City of Corpus Christi

Meeting Agenda - Final

Planning Commission

Wednesday, April 17, 2024

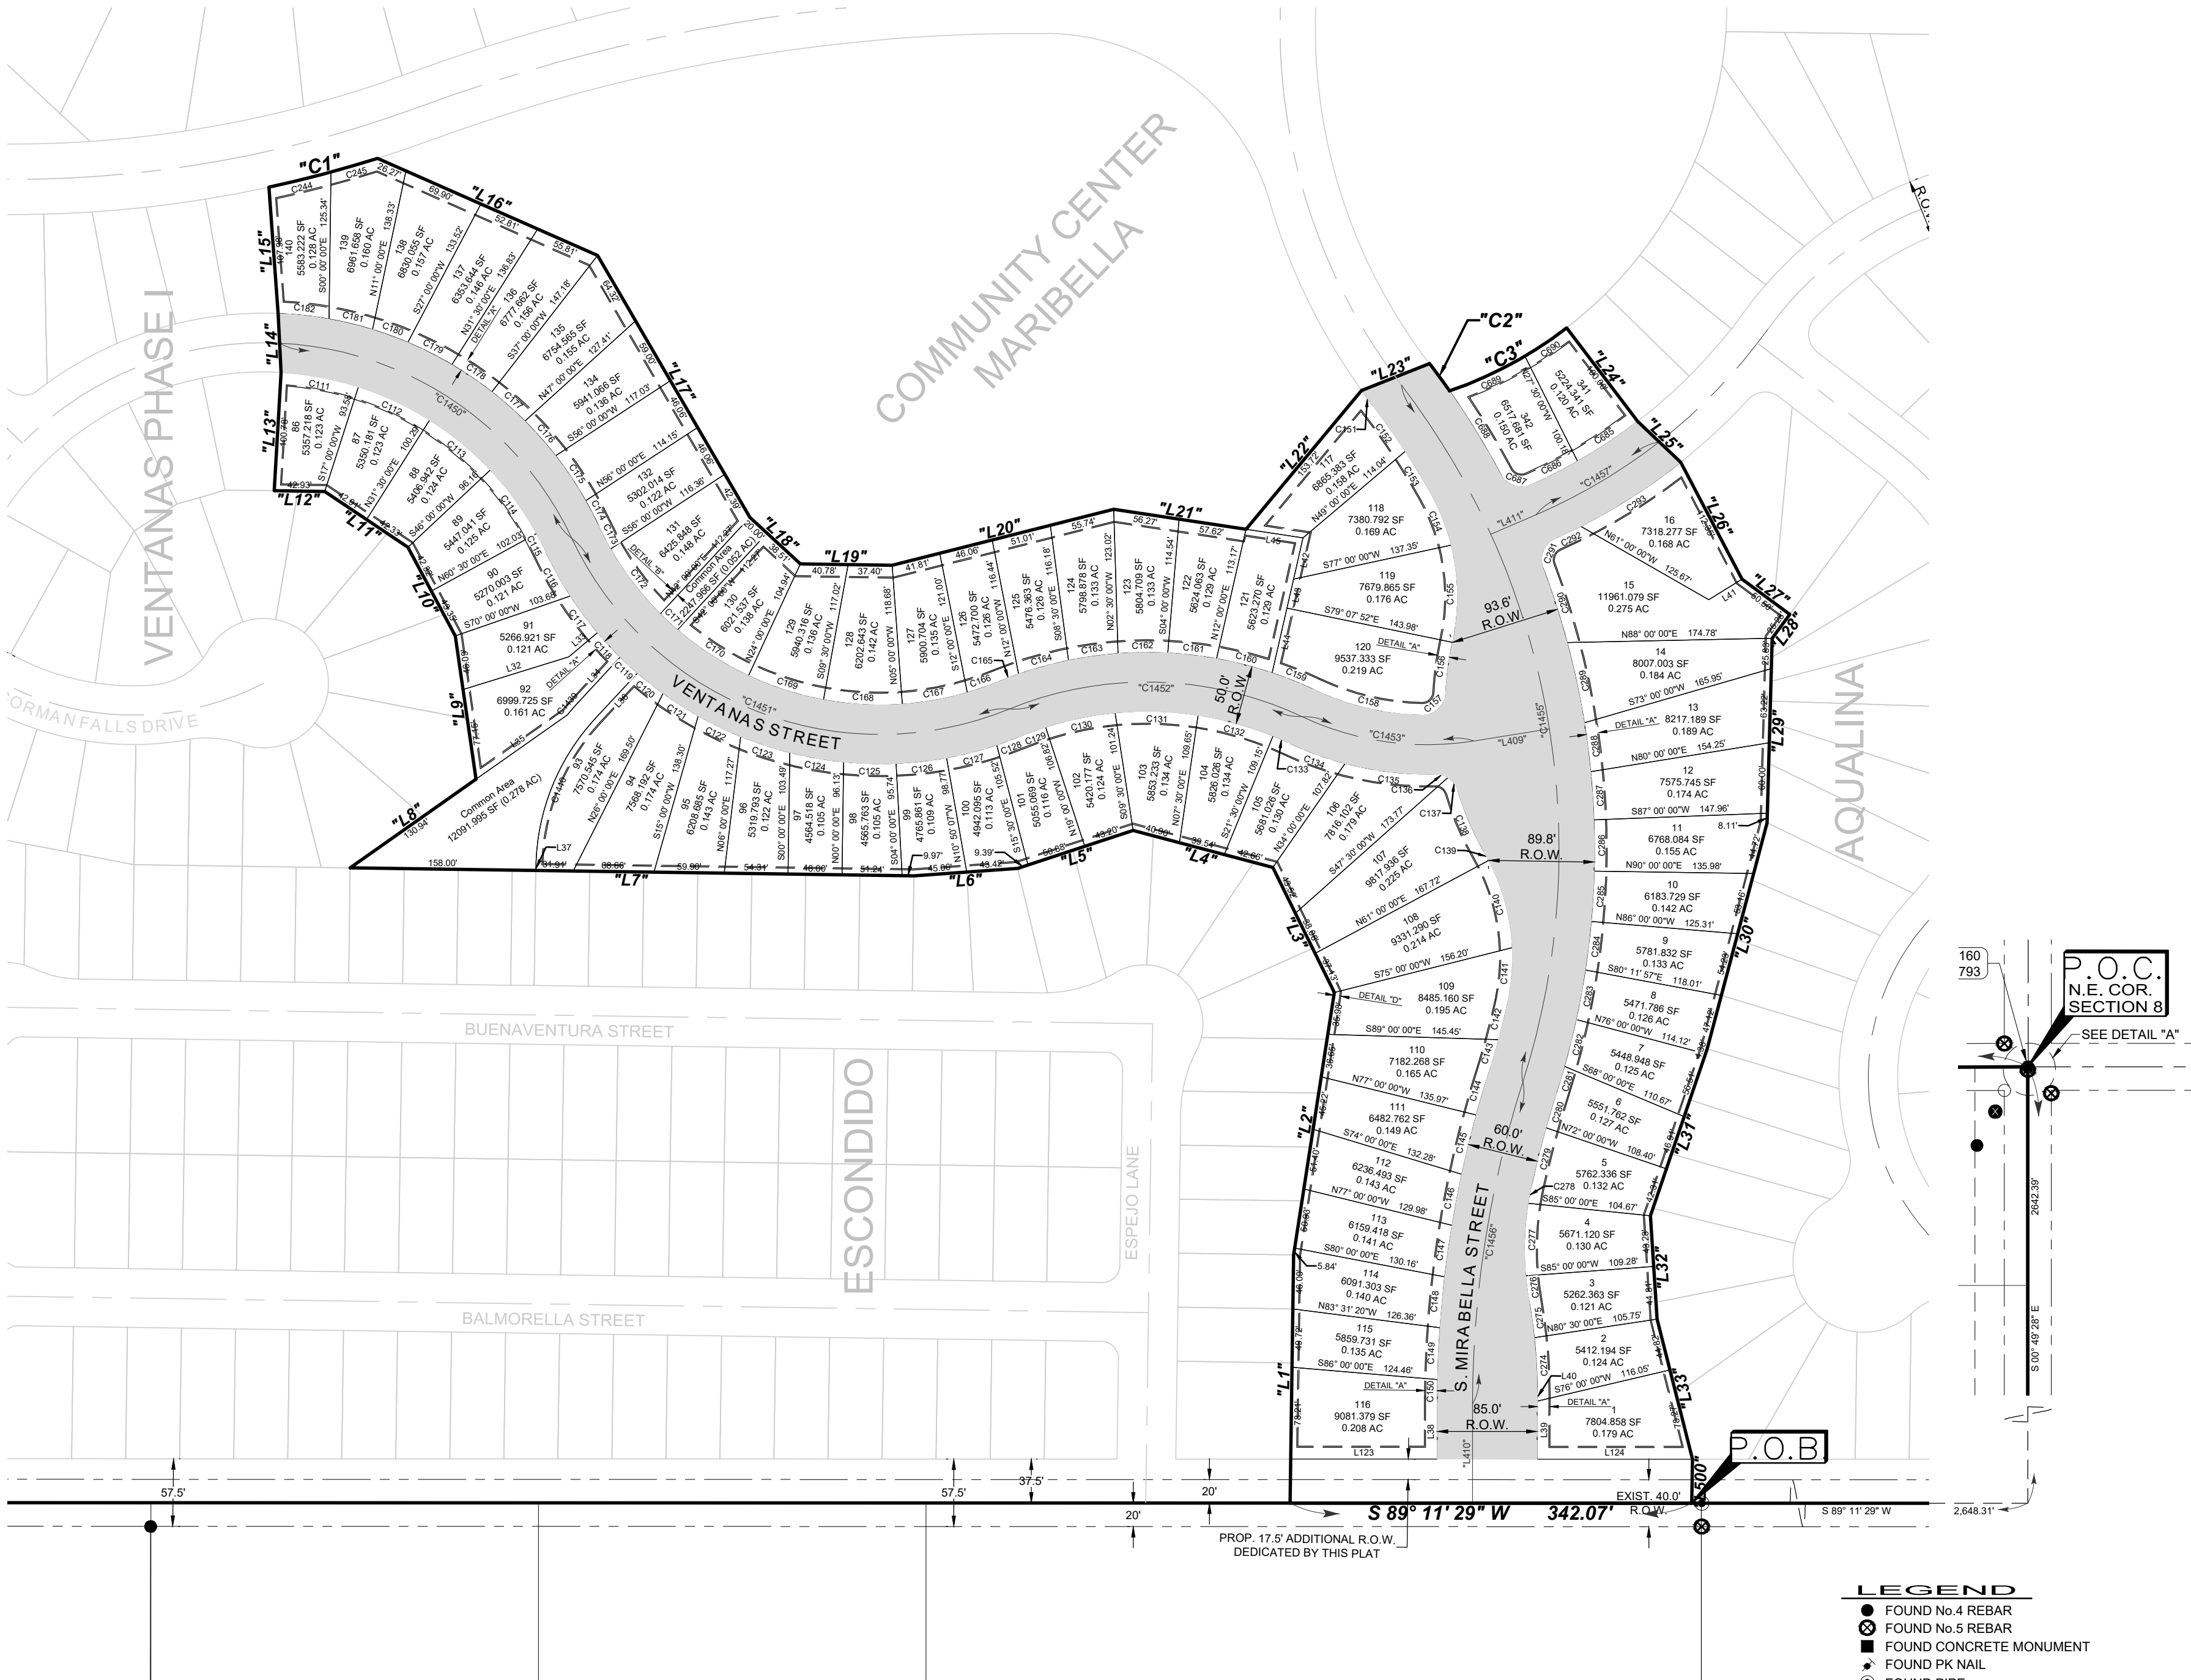
Comment ID	Page Reference	Annotation Type	Author : Department	Status	Review Comments	Applicant Response Comments
1	SHEET 1	Note	Mark Zans : DS	Open	Location map - the site shown on the location map does not match the location of the plat shown on this page. Increase font size so that streets are readable.	
2	SHEET 1	Note	Mark Zans : DS	Open	Hatch area that will be for road dedication and provide square footage of that dedication.	
3	SHEET 1	Note	Mark Zans : DS	Open	Provide doc# for the dedication of common area.	
4	SHEET 1	Note	Mark Zans : DS	Open	Label as to the usage of the common areas on this plat.	
5	SHEET 1	Note	Mark Zans : DS	Open	Provide street names for all streets. Street names shall match the names of those that are put on the preliminary plat.	
6	SHEET 1	Note	Mark Zans : DS	Open	Place the square footage of each plat under the lot number.	
7	SHEET 1	Note	Mark Zans : DS	Open	Please provide block numbers on the plat.

8	SHEET 1	Note	Mark Zans : DS	Open	Label the surrounding parcels with the phases of the Crosstown coves plat.	
9	SHEET 1	Note	Mark Zans : DS	Open	Per the UTP, the interior roadway is a C-3 collector road and minimum width is to be 75'. This may change if plat is done as a PUD.	
11	SHEET 1	Note	Mark Zans : DS	Open	Make this page 2 of 2 for the plat.	
12	SHEET 1	Note	Mark Zans : DS	Open	Please see City of Corpus Christi / Platting website for final plat templates to use for plat formats.	
13	SHEET 1	Callout	Mark Zans : DS	Open	Change subdivision to Final Plat of Crosstown Coves	
14	SHEET 1	Callout	Mark Zans : DS	Open	Rename Phase to a name which makes sense.	
23	SHEET 1	Note	Mark Zans : DS	Open	TxDOT comments- No increase in storm water discharge to State right-of-way shall be accepted by TxDOT. TxDOT Permits will be issued in accordance with the access management standards and all applicable state and federal laws, including rules

24	SHEET 1	Note	Mark Zans : DS	Open	<p>Fire comments 8-14</p> <p>8□ Infor, □ To negotiate a turn in a cul-de-sac, the minimum required distance is a 96 ft diameter in accordance with section 503.2.5 Dead ends. Dead-end fire apparatus access roads more than 150 feet (45 720 mm) in length shall be provided with an approved area for turning around fire apparatus. Turn around provisions shall be provided by means of a 96-foot diameter cul-de-sac (Section 503.2 and Appendix D. Cul -de -Sac turning diameter shall be 96 minimum.)</p> <p>9□ Infor, □ Note: An accessible road and a suitable water supply is required once construction materials are brought on site.</p> <p>10□ Infor: □ 503.4 Obstruction of fire apparatus access roads. Fire apparatus access roads shall not be obstructed in any manner, including the parking of vehicles. The minimum widths and clearances established in sections D103 shall always be maintained.</p> <p>11□ Infor: □ 503.3 Marking: Where required by the fire code official, approved signs, or other approved notices the include the words NO PARKING-FIRE LANE shall be provided for fire apparatus access roads to identify such roads to prohibit the obstruction thereof. The designation of a fire lane can be marked with conspicuous signs which have the words: Fire Lane-No Parking at 50-foot intervals. In lieu of signs, fire lanes may be marked along curbing with the wording, Fire Lane-No Parking at 15-foot intervals.</p> <p>12□ Infor. □ As the new subdivision develops, streets</p>

25	SHEET 1	Note	Mark Zans : DS	Open	<p>Fire comments - 1- 7</p> <p>1 Infor: Although presently this proposed subdivision is outside city limits, it is projected to be annexed soon. Consideration should be given to the standards for fire protection as follows:</p> <p>2 Utility Residential fire flow should have at least 750 GPM with fire hydrants spaced every 600 feet.</p> <p>3 Infor: 503.2.3 Surface. Fire apparatus access roads should be designed and maintained to support the imposed loads of fire apparatus and shall be surfaced to provide all weather driving capabilities and capable of supporting the imposed load of fire apparatus weighing at least 75,000 pounds.</p> <p>4 Infor: IFC 2015 Sec. 503.2.1 Dimensions Fire apparatus access roads shall have an unobstructed width of not less than 20 feet, exclusive of shoulders</p> <p>5 Infor: Where a hydrant is located on an fire apparatus access road, the minimum road width shall be 26 feet, exclusive of shoulders.</p> <p>6 Infor: "The minimum required width of 20 feet that shall be maintained means a clear unobstructed path that allows the passage of fire apparatus.</p> <p>1. Where Fire Apparatus Access is constructed to the minimum of 20 feet, no parking is allowed</p>

26	SHEET 1	Note	Mark Zans : DS	Open	Park Dev. Fee: 73 lots x 462.50 = \$33,300.00	
29	SHEET 1	Note	Mark Zans : DS	Open	Please provide a addressed plat with addresses for each lot. Do not address the small common areas unless their is a building planned for the lot. (i.e. Clubhouse,, HOA office)	
30	SHEET 1	Note	Mark Zans : DS	Open	AEP Texas Distribution request a 5 electric easement in the front of every lot off the ROW for front lot distribution. It can be the first 5 or the second behind a UE if there is one.	
33	SHEET 1	Note	Mark Zans : DS	Open	Traffic comments 1-8	
34	SHEET 1	Note	Mark Zans : DS	Open	<p>Traffic comments 9-18</p> <p>9 Informational: Public improvement plans shall include all signage and pavement markings needed for traffic operations (e.g. signage, striping, traffic mitigation devices) in addition to standard "regulatory" STOP and street name blade sign installations. Additionally, cul-de-sacs must include either NO OUTLET or DEAD END signage. Temporary Dead-Ends should include the appropriate object markers and one-way streets must include signage for any one-way designations and affected side streets. Reference: Texas MUTCD based on CC UDC Article 8.1.3.A</p> <p>10 Informational: All traffic signs shall be furnished and installed by the Developer in accordance to specifications of, and subject to,</p>

15	SHEET 2	Note	Mark Zans : DS	Open	Make this page 1 of 2 for the plat.	
16	SHEET 2	Note	Mark Zans : DS	Open	Please check City of Corpus Christi / Platting website for plat templates to change format of plats.	
17	SHEET 2	Note	Mark Zans : DS	Open	Remove the legal description from the plat. It is not needed.	
18	SHEET 2	Note	Mark Zans : DS	Open	Make this page the title page of the plat. See City of Corpus Christi / Platting for platting templates and formatting.	
19	SHEET 2	Note	Mark Zans : DS	Open	Move the County Clerks Certification to the edge of the plat so that a seal can be placed on the plat.	
20	SHEET 2	Callout	Mark Zans : DS	Open	Change chairman's name to Michael Miller	
21	SHEET 2	Callout	Mark Zans : DS	Open	Fix signature line.	
22	SHEET 2	Callout	Mark Zans : DS	Open	Add Phase name to this certification.	
27	SHEET 2	Callout	Mark Zans : DS	Open	Insert phase name here	
28	SHEET 2	Callout	Mark Zans : DS	Open	Change acreage being platted to acreage of this phase of the plats.
